SERVICE BULLETIN

TM-211/411 AF GAIN CONTROL PART CHANGE

9-16-85

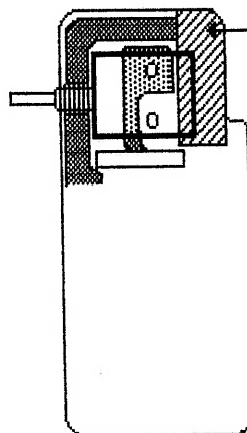
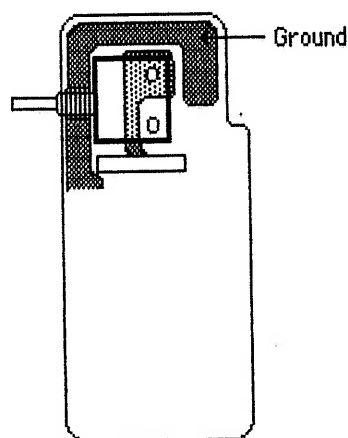
The original AF Gain control (R05-3424-15) has been replaced by a new part, with a new part number. The new part differs in mounting method and appearance. This should cause the operator no problems, and only requires a little change in the mounting method. The diagrams below are self explanatory:

R05-3424-05 or
R05-3424-15

Old style

R05-3433-05

New style

Place a piece of mylar tape in this area when installing the new type switch. The new switch is a little larger and must have some insulation beneath it to prevent shorts with the ground foil.
